1. Isn't reset negated when the input power source is unstable?

Figure 1

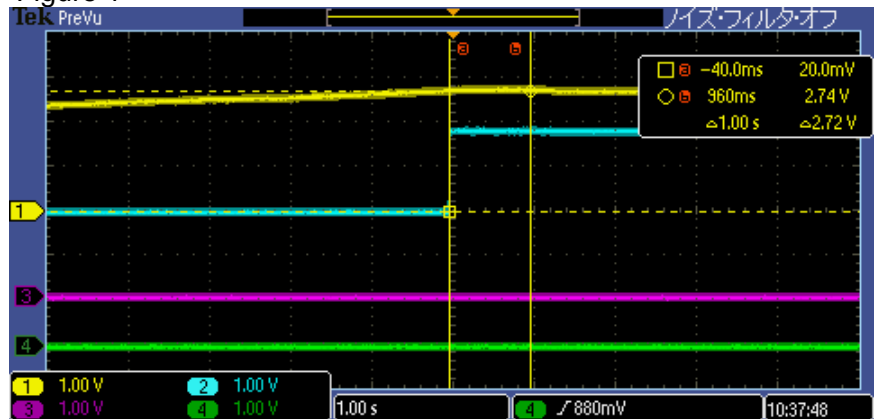
When raising VCC7 gradually, PWRHOLD is asserted at about 2.74V.
Normally, PORX is negate in 20ms, but is not negate in this state

Figure3

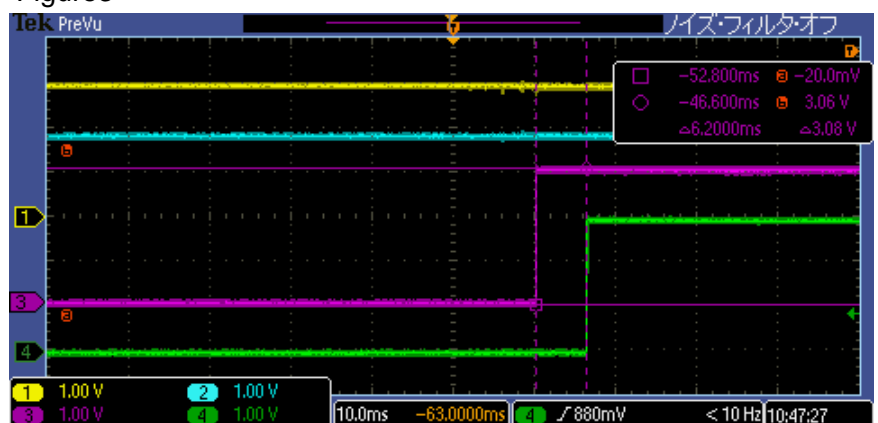
PWRHOLD is asserted until 3.3V is outputted stable.
The 3.3V is outputted stable and PORZ is negated after the time of a sequence.

>Is this working correct?

>Is NRESPWRON High in the case of VBAT=2.8V?
